780 BLANSHARD - REHABILITATION + ADDITION

HAV00034 CONCURRENT WITH REZ00825

Bubbled areas indicate revisions compared to the previously submitted plans

DATE	REV	ISSUE DESCRIPTION
2022-02-24	1	REZONING PRE-APPLICATION
2022-06-01	2	OPEN HOUSE PROGRESS SET
2022-06-21	3	REZONING APPLICATION
2023-03-23	4	HAP & REZONING RESUBMISSION

ELEVATION NORTH

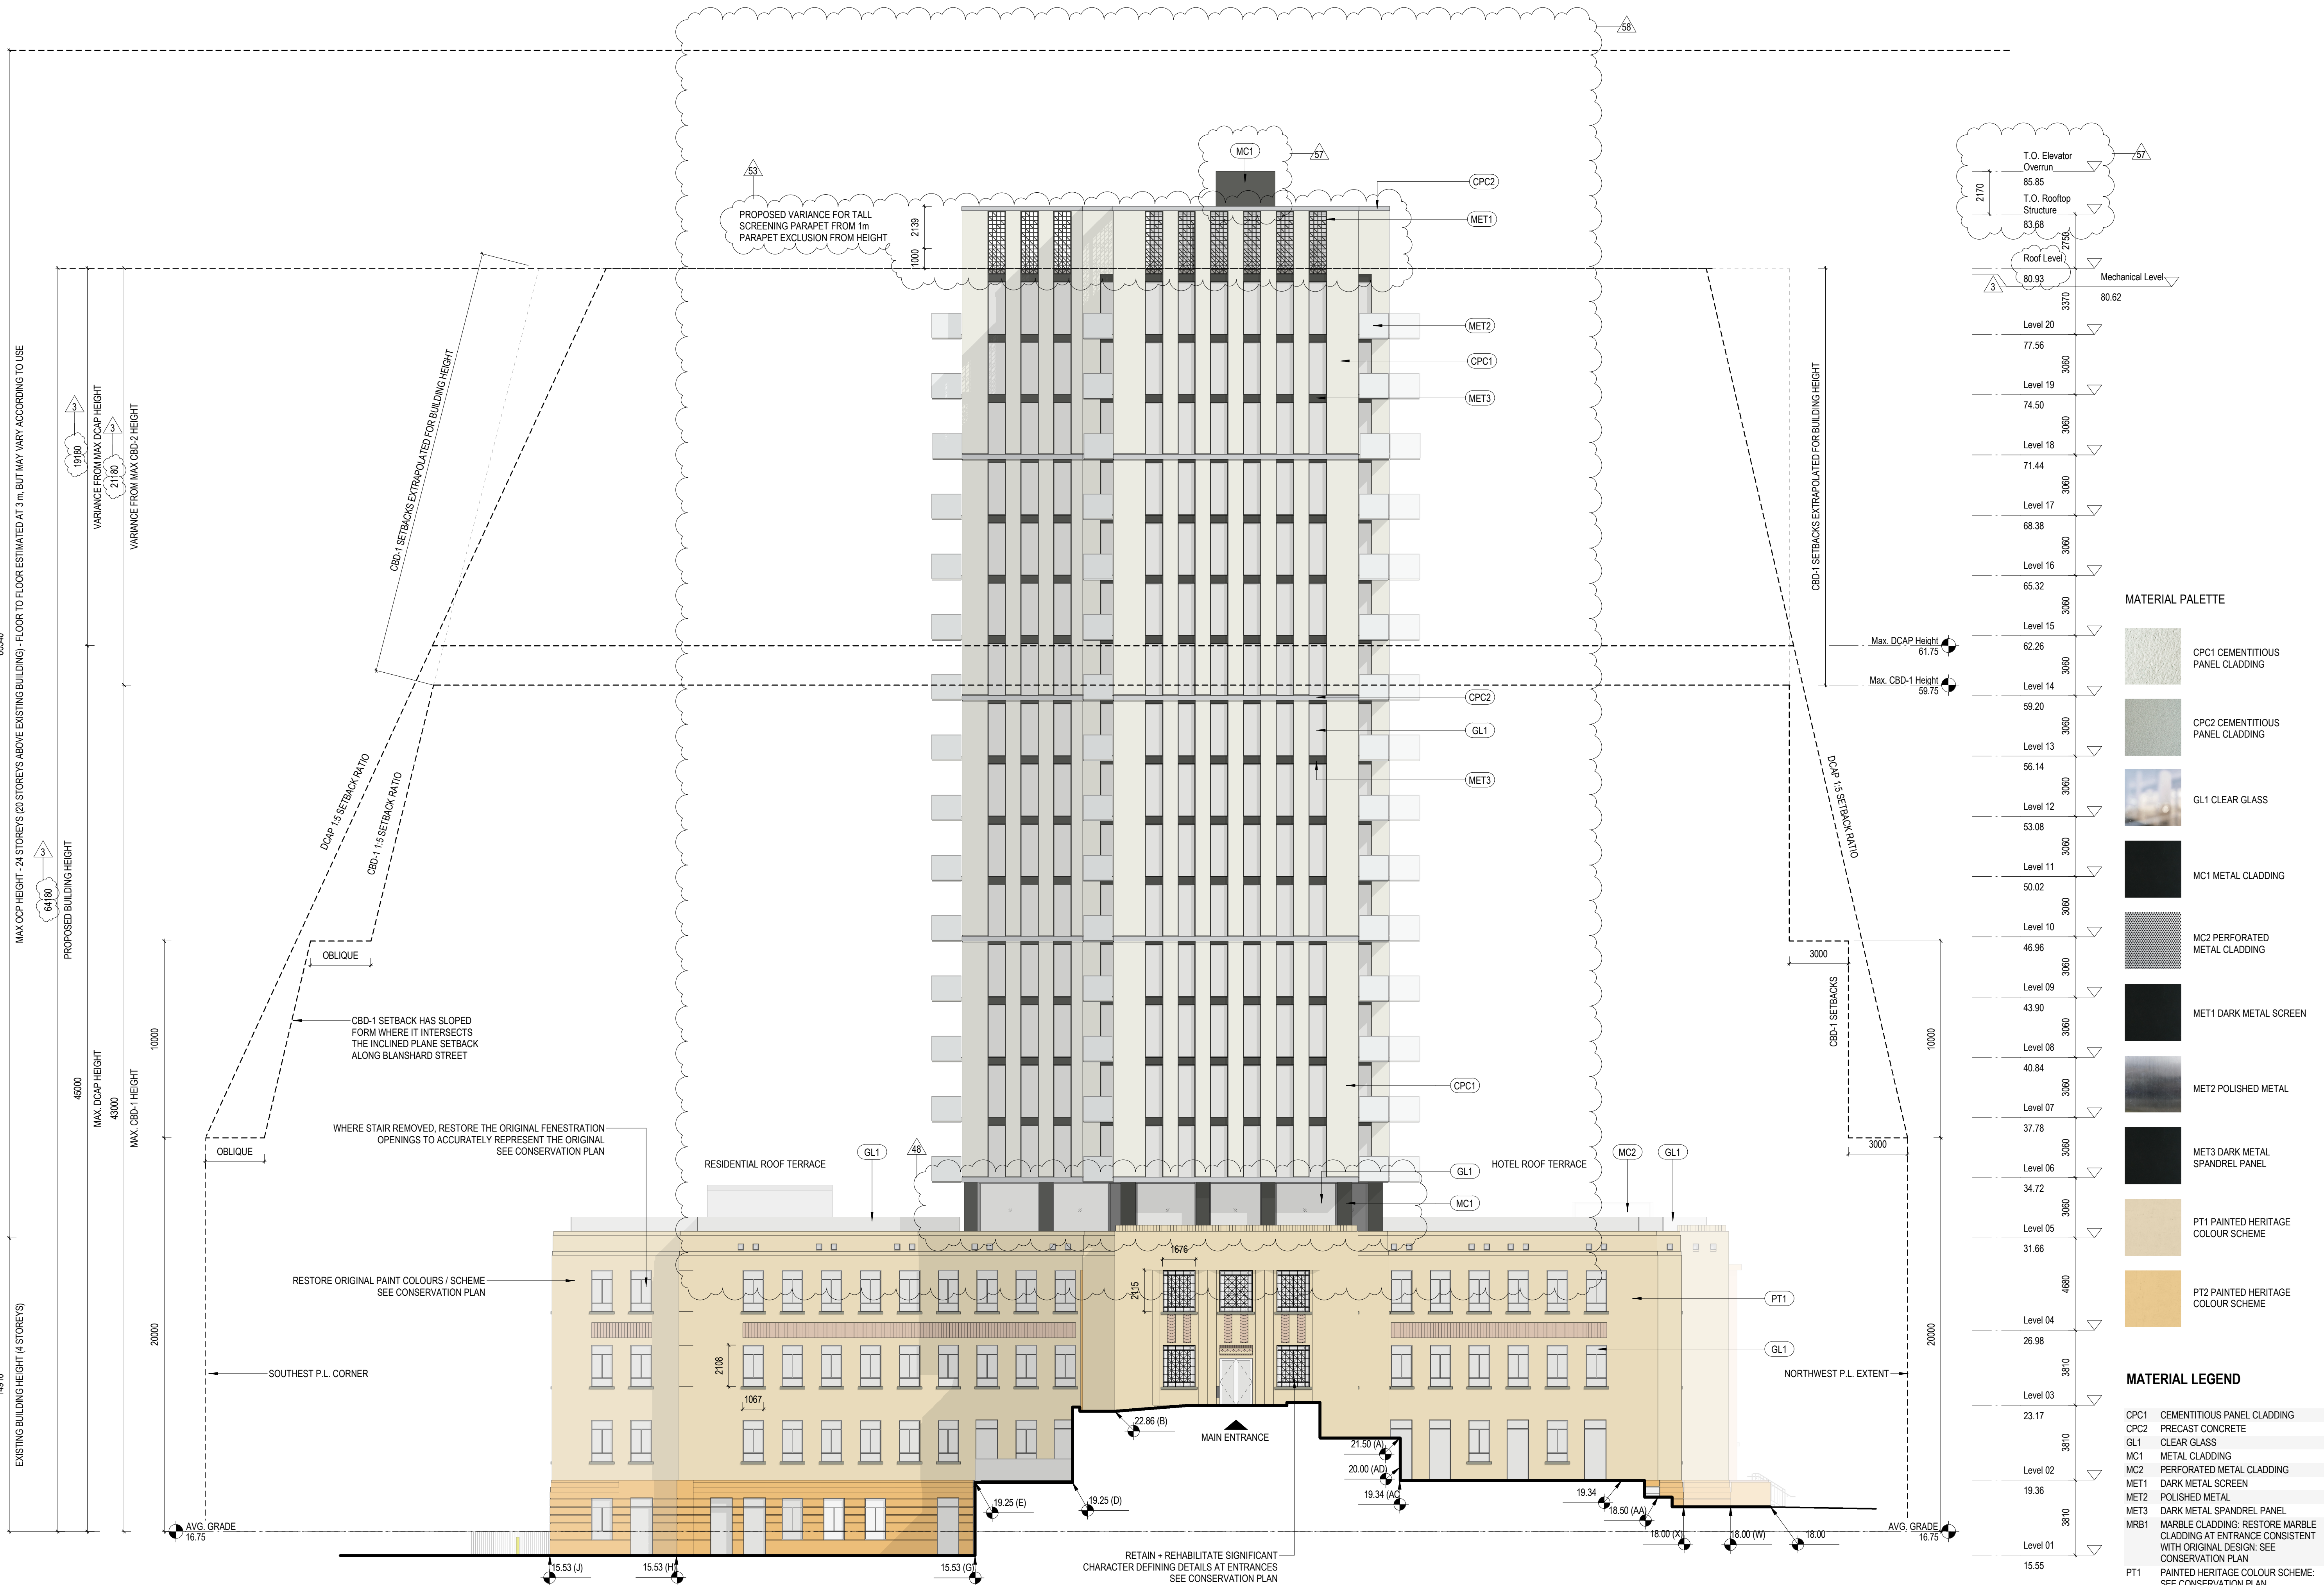
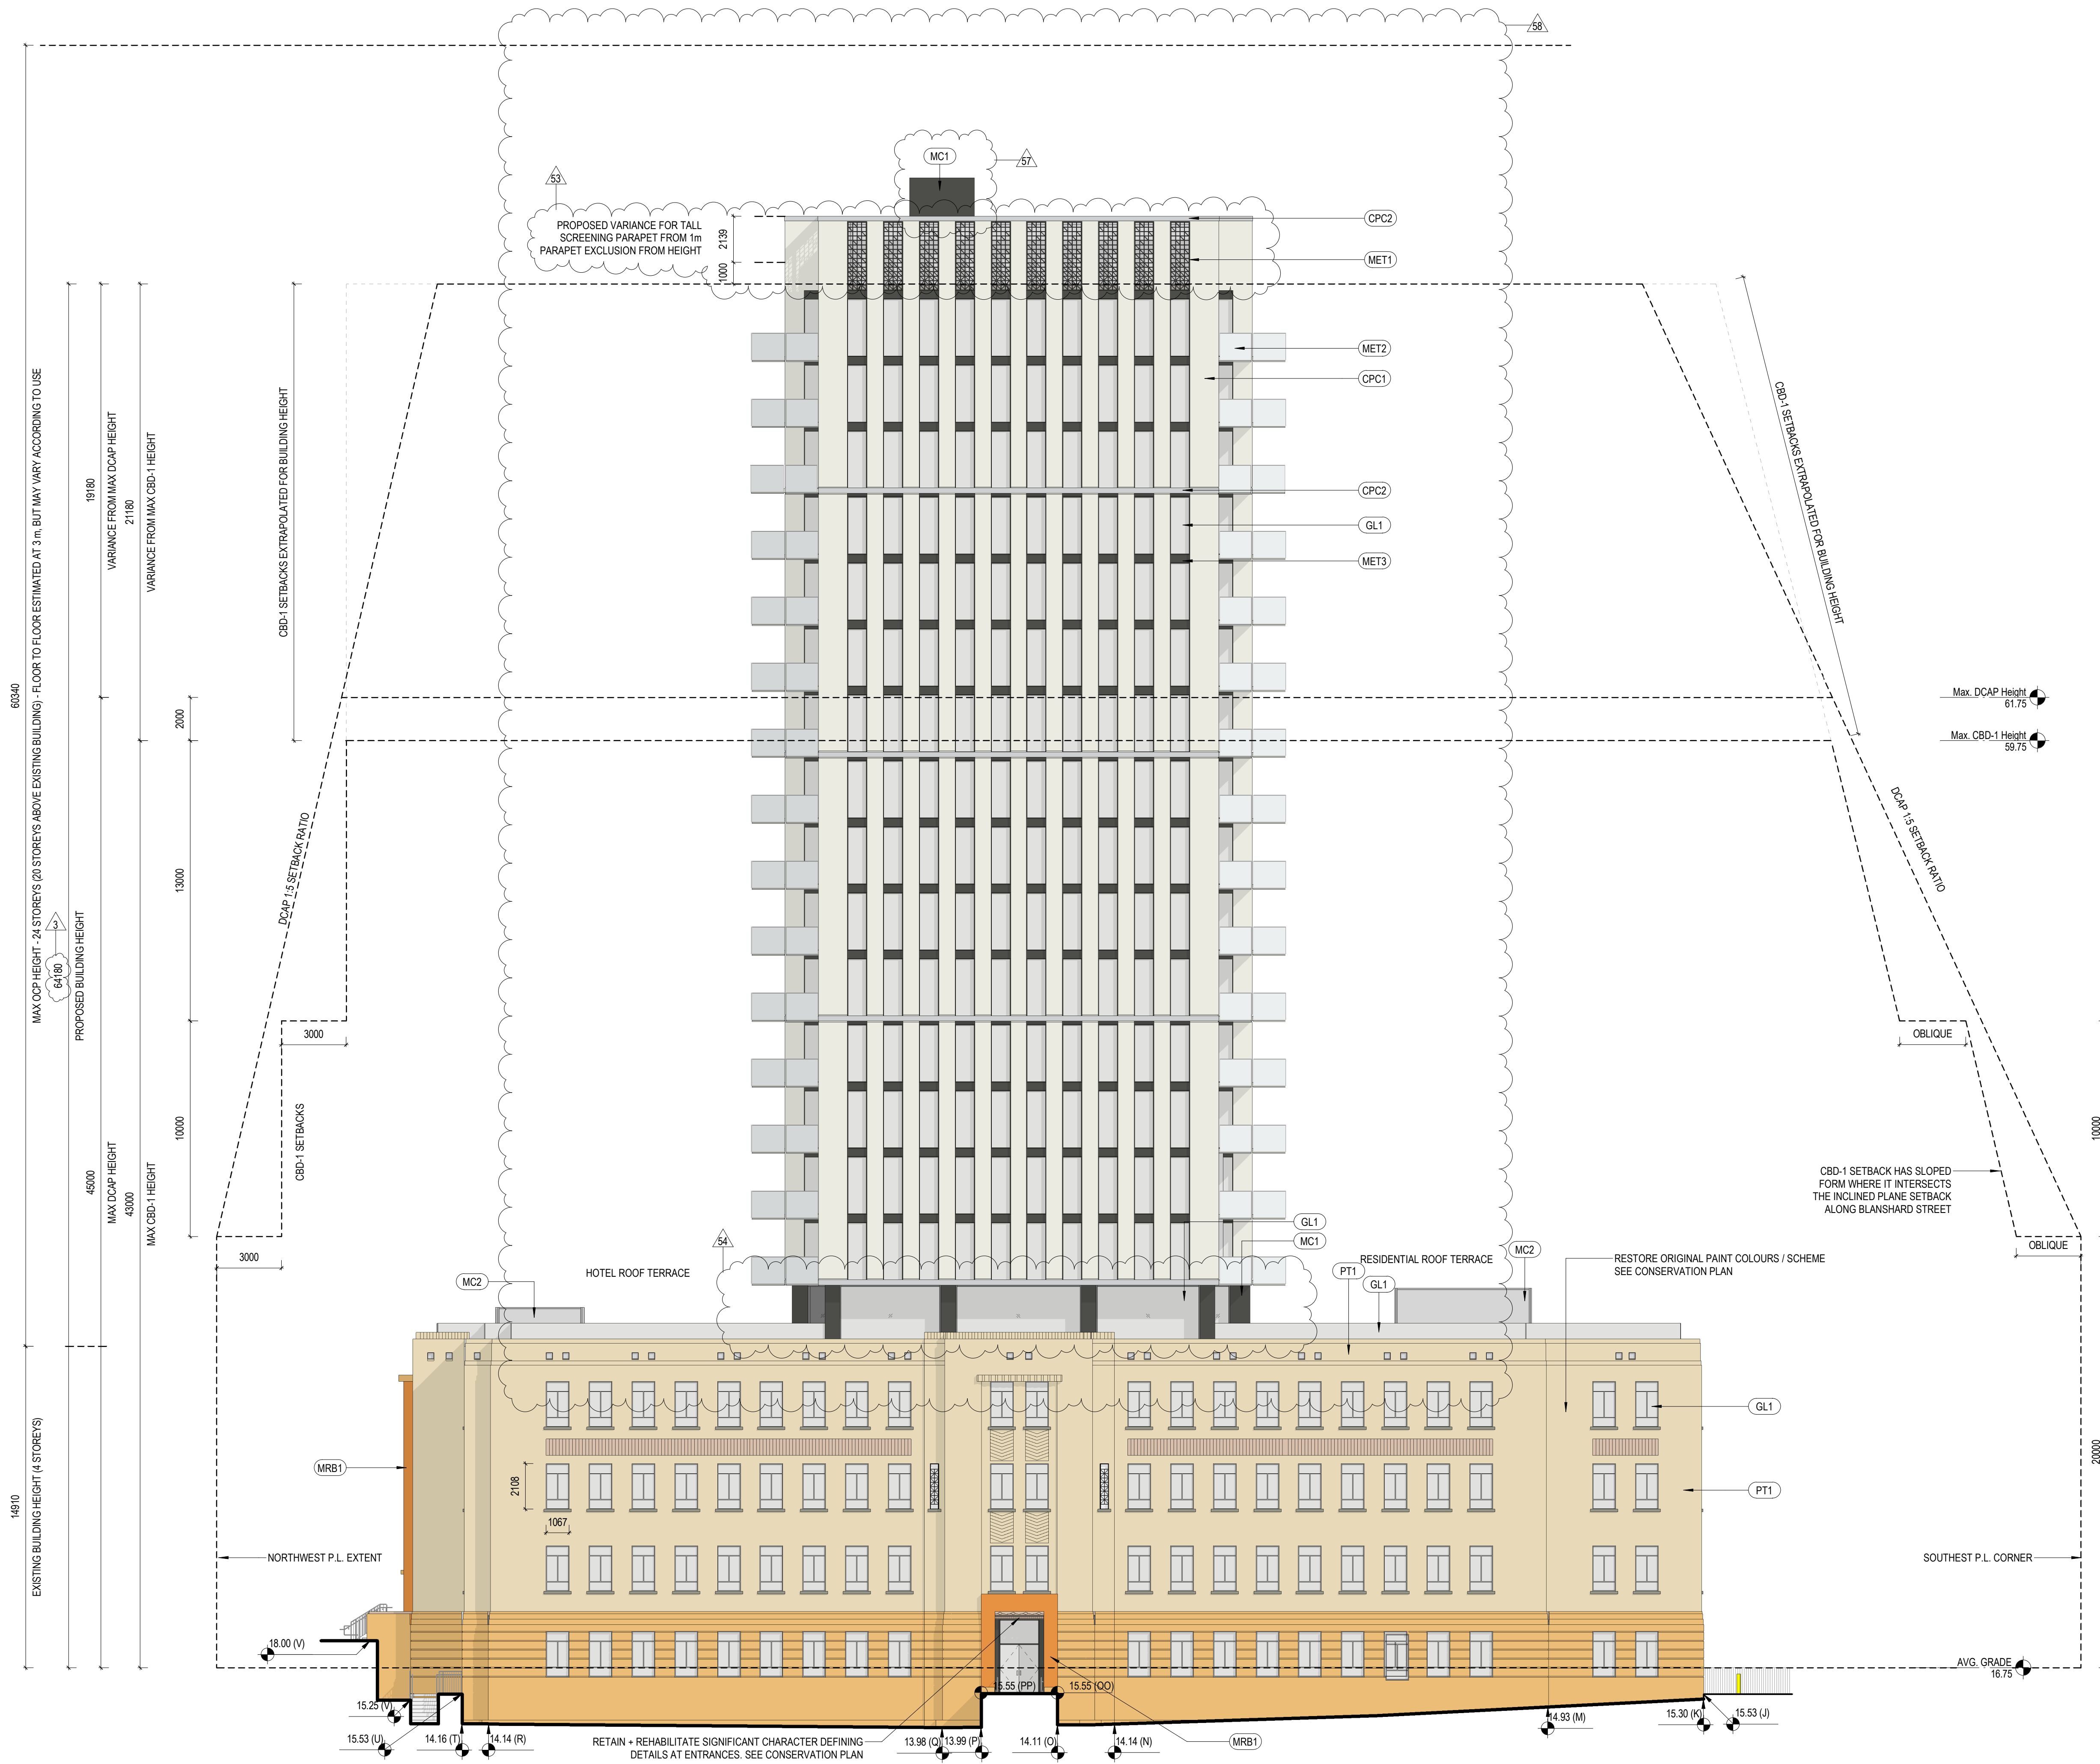
3 Building Height reduced in response to ARS Comment #22. See additional analysis, rationale, and visualizations in Response Letter and Sections 10 and 11 of the Large Project Supplementary Information Booklet.

48 The inset face of the glazed facade at Level 05 has been updated for the revised building massing and to respond to ARS Comment #23. See additional visualizations and rationale in response Letter and Sections 10 and 11 of the Large Project Supplementary Information Booklet.

53 Tall screening parapet proposed as part of heritage-sensitive design and in response to ARS Comment #25. See additional rationale in Response Letter, Heritage Conservation Plan, and Large Project Supplementary Information Booklet.

57 For HAP coordination, Elevator access added to mechanical room on Roof, which has increased the height of the Rooftop Structure.

58 Addition massing and facade design updated in response to ARS Comments #22, #23, #24, and #25. See other bubbled changes, the Response Letter, and Sections 10 and 11 in the Large Project Supplementary Information Booklet for additional information and rationale.
